UNITED STATES PATENT AND TRADEMARK OFFICE

APPLICATION NO.	FILING DATE	FIRST NAMED INVENTOR	ATTORNEY DOCKET NO.	CONFIRMATION NO.
10/689,838	10/22/2003	Volker Dieckmann	000137.00030	4246

Office Action Summary

DETAILED ACTION

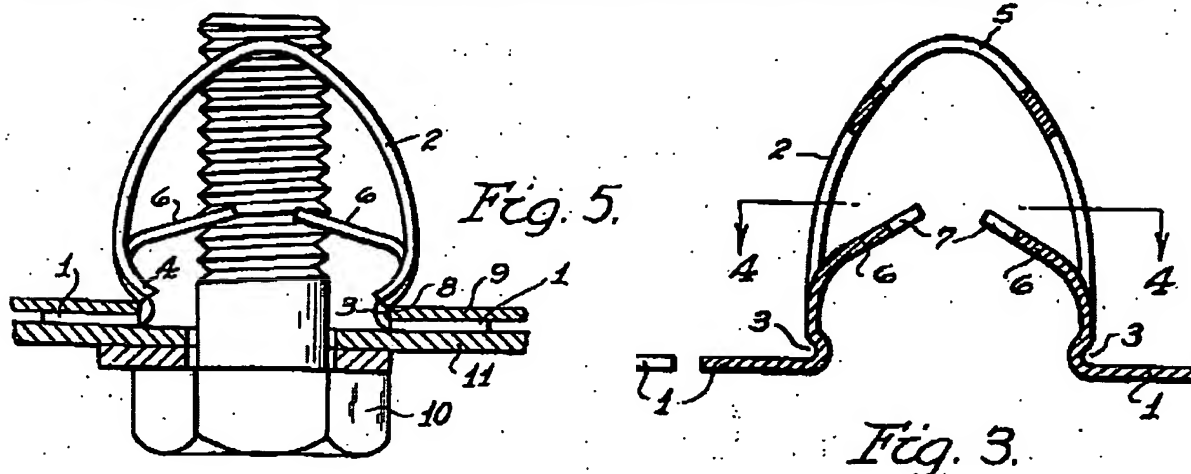
Further Re claim 4: said at least one supporting part includes a tubular rail drawn out of the spring bottom and wherein the walls are curved from said recess to said arched bottom. A prong is considered a rail:

Further Re claims 7-8: Burke teaches that the support lobes (6) have a length along the spring bottom shorter than a distance between said latching recesses (Fig 5, left 6 will not meet right 6, thus the length is shorter than the aperture between recesses.

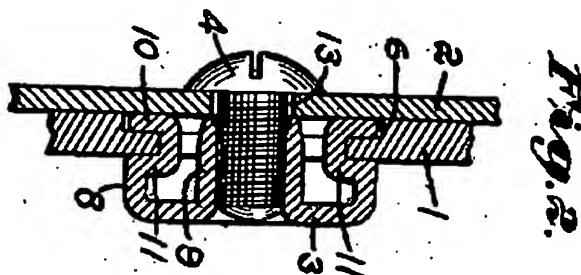
Further Re claim 3: said at least one supporting part (26) comprising a portion of one of said arms that extends at an angle to the respective one of the latching recesses towards spring bottom.

Further Re claims 7-8: Meyer teaches that the support lobes (26) have a length along the spring bottom shorter than a distance between said latching recesses (Fig 3, left 26 will not meet right 26, thus the length is shorter than the aperture between recesses.
